Subject: **OSCILLATION ON DATA LINES WHEN
 USING 74HC244 DATA BUFFERS**

Model: **APR-24**

Serial No: **10,001-10,122**

Figure 1

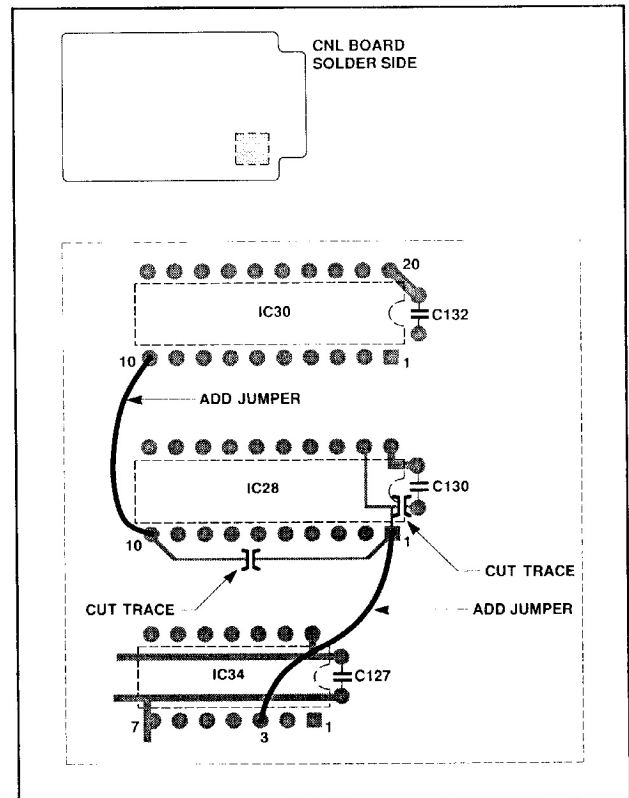
Oscillation may occur on the CNL data lines due to an instability caused by the multiple feedback loops provided by the data lines, the buffers, and their interconnecting power lines.

To correct this problem, change the addressing of CNL IC28 (74HC244) from "continuous" to "selected" by modifying each CNL Board as described in the following procedure.

1. Cut trace between IC28-1 and IC28-10.
2. Cut trace between IC28-1 and C130.
3. Add jumper between IC28-10 and IC30-10.
4. Add jumper between IC28-1 and IC34-3.
5. Secure both jumpers with SONY Bond SC-108.
